## Mandatory Service Bulletin

**Mandatory update to Sedecal SoftConsole 5.5 to prevent modifications of exposure values, mandatory update to DMC firmware V11R3b5 and mounting of revised resistive arrestor strap necessary**

Task	
Timing	Category	Subject	
 <b>Immediately. Completion anticipated by date 31.01.2016</b>	 <b>Mandatory for all affected sites</b>	<input checked="" type="checkbox"/>	<b>PowerHelp complaint / HQ issue: PR1406020002, PR1411200006, PR1501190003</b>
		<input checked="" type="checkbox"/>	<b>Problem affects serial number(s) / batch(es) listed below.</b>

Figure 1

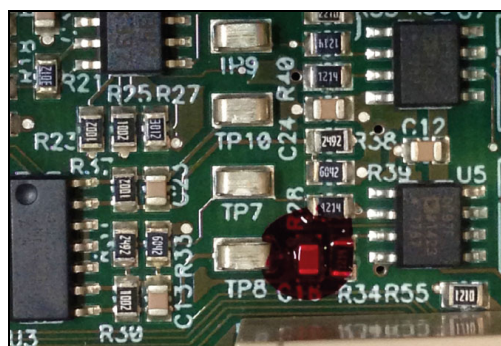
- Fix the DMC board with 4 plastic screws and isolate the board from the metallic mounting plate by 4 plastic spacers.
- After the replacement it is necessary to protect the DMC board SAT-A3539-01 against possible damages (e.g. during the measurement of the voltage on the Test Point TP8). For that it is necessary to apply a coating protection over the C16 capacitor before measuring the voltage. Use Loctite 7400 for coating.
- In case the Loctite 7400 is not available use a piece of electrical tape over the C16 capacitor. In case the tape is used it should be removed after adjusting the TP8 voltage.

Figure 3

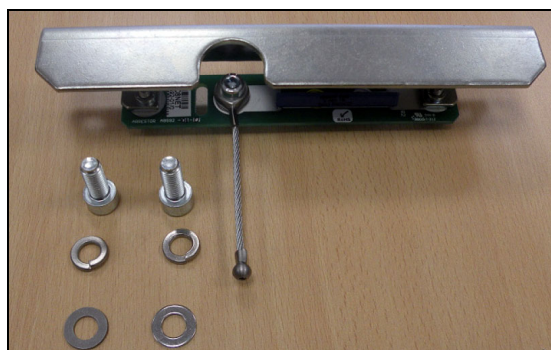
*Solution* Replace the old arrestor strap with the revised arrestor.

SC+A9365-01 Resistive arrestor kit

Figure 6 - Bottom view of the mobile unit

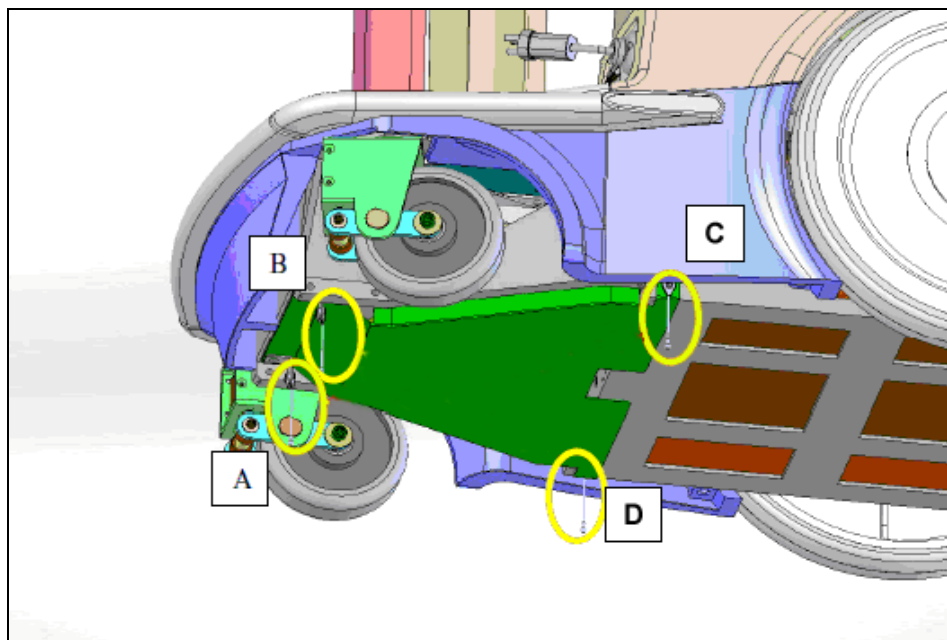
- If no arrestor is mounted: 15 minutes
- If arrestors are mounted at position A or B: 15 minutes (see figure 6)
- If arrestors are mounted at position C or D: 120 minutes (see figure 6)

- (3) Check if an arrestor is directly fixed to the frame (see figures below for possible locations).
- (4) Only required if an arrestor is mounted at position C or D:  
Remove the covers of the DX-D 100 / DX-D 100 wireless as explained in the troubleshooting chapter of the service manual.

Figure 9

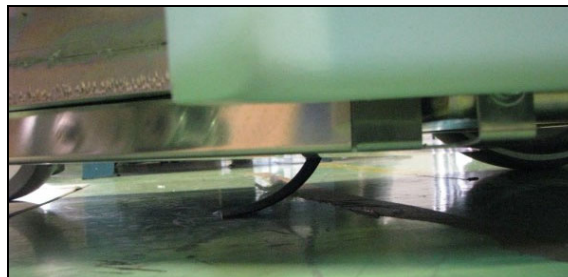
- (5) In case that an arrestor is present: Remove the old arrestor from the unit.

If one of the arrestors is a rubber arrestor:  
Cut the rubber.

Figure 10 - Location of the column cable protector cover

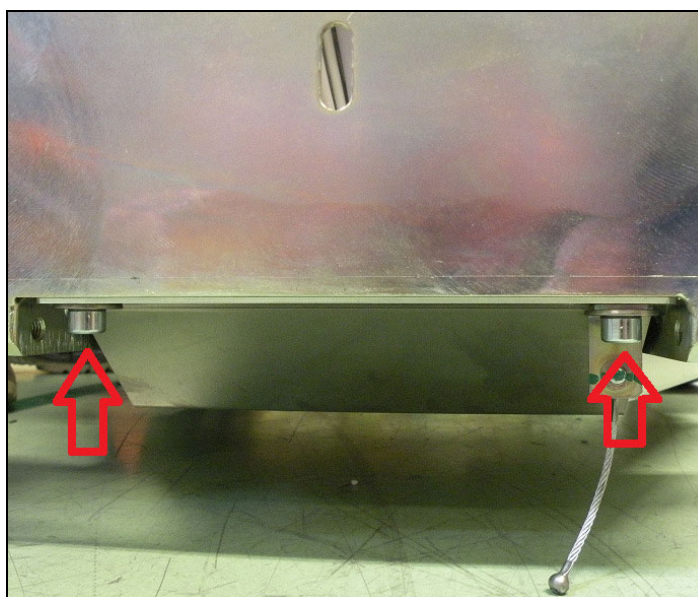
- (6) Remove both screws shown in the figure below.  
See also figure 4: The screws are located at position A and B.

Figure 11 - Column cable protector cover without screws

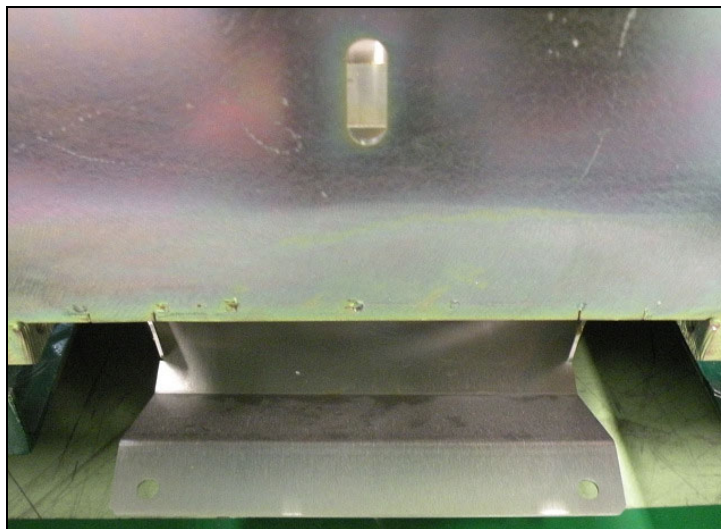
- (7) After removing both screws, the column cable protector cover will go to down position as shown in the figure below.

Figure 13 -  
Locations of the resistive arrestor assembly  
fixing screws

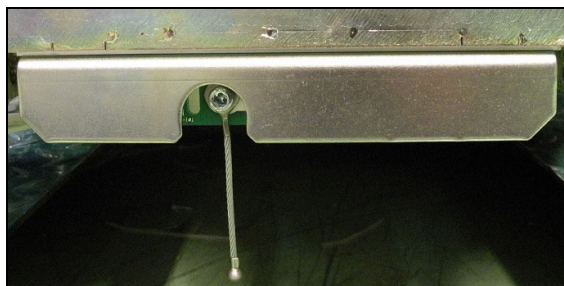
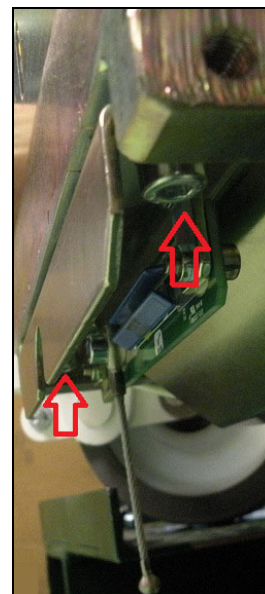
- (8) Lift the column cable protector cover to the original position. Install the resistive arrestor assembly with the screws and the washers included in the kit as shown in the figures below.
